ENVIRONMENTAL & NATURAL RESOURCES COMMISSION STAFF REPORT
Meeting Date April 21, 2025

REPORT TO: Environmental and Natural Resources Commission
REPORT FROM: Shann Finwall, AICP, Sustainability Coordinator
PRESENTER: Shann Finwall, AICP, Sustainability Coordinator
AGENDA ITEM: Saint Paul Police Training Facility, 2621 Linwood Avenue East - Wetland Buffer Variance

Motion to approve a wetland buffer variance resolution and wetland buffer mitigation strategies for a new training facility to be constructed at 2621 Linwood Avenue East.

1 LANDSCAPE PLAN 1" = 50'

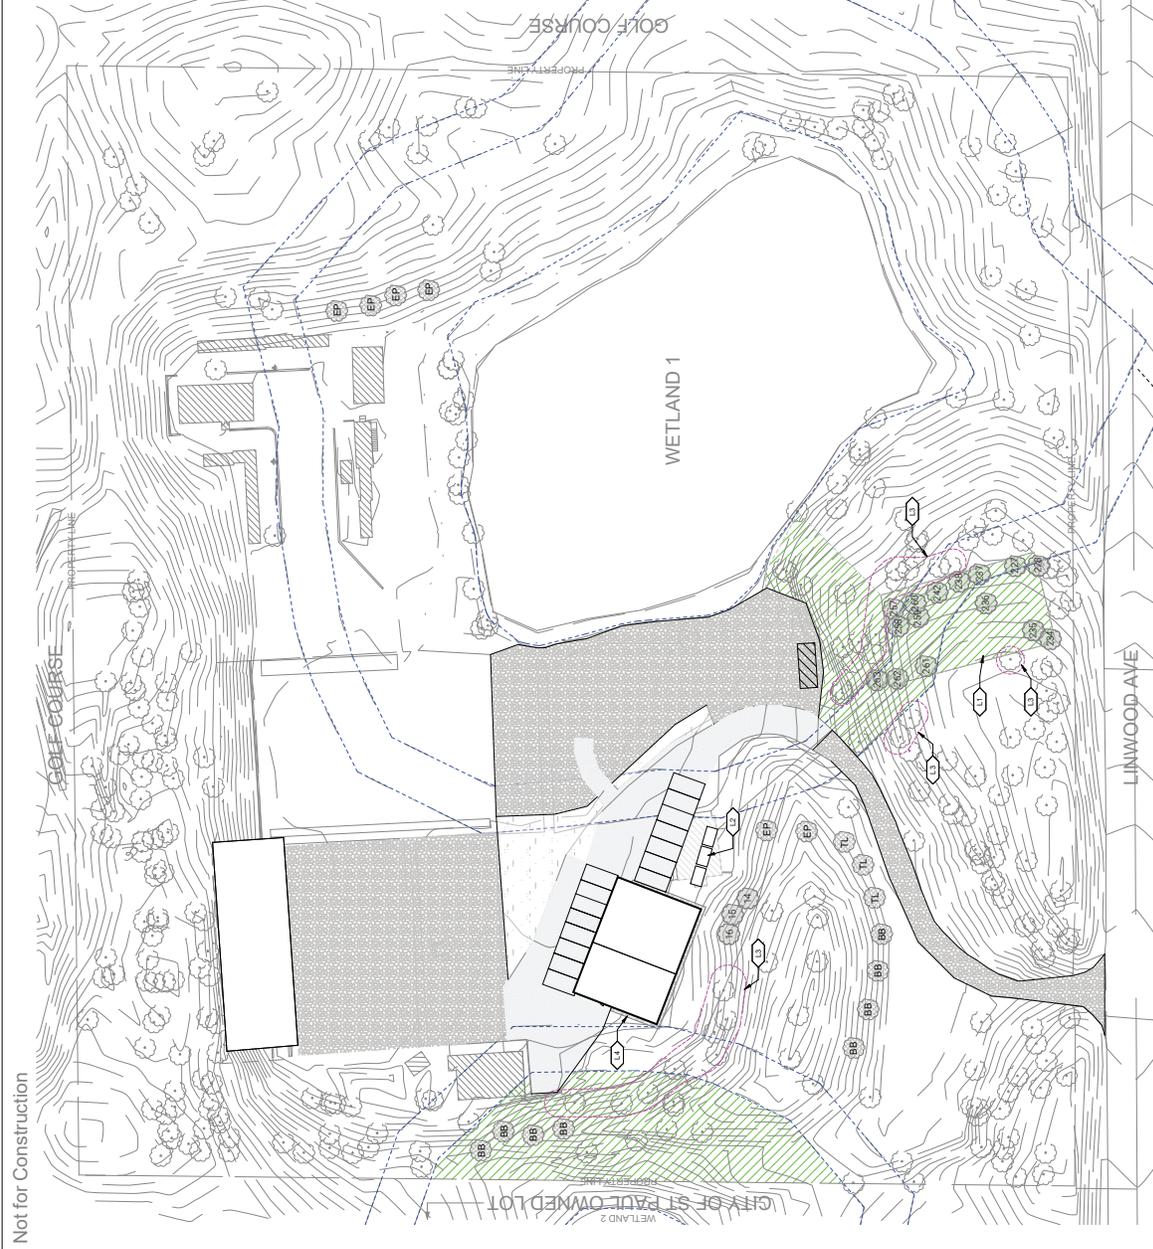
2. Tree Impacts: The tree survey identifies 308 significant trees on the site, however, the overall caliper inches of significant trees are not included. The site demolition plan shows the removal of 18 significant trees, however, the size and species of the trees are not included. Tree replacement cannot be determined without additional information, but it is likely that the tree removal is less than 20 percent of the overall caliper inches of trees on the site. In that case the required tree replacement is 18 – 2 diameter inch trees.

3. Tree Replacement: The landscape plan includes 18 – 2 diameter inch trees.

- a. Identify which trees will be removed on the tree survey and the size and species on the site demolition plan.
- b. Add the City's tree replacement calculation to the plans. The tree calculation will include the overall caliper inches of significant trees on the site versus the caliper inches of trees removed.
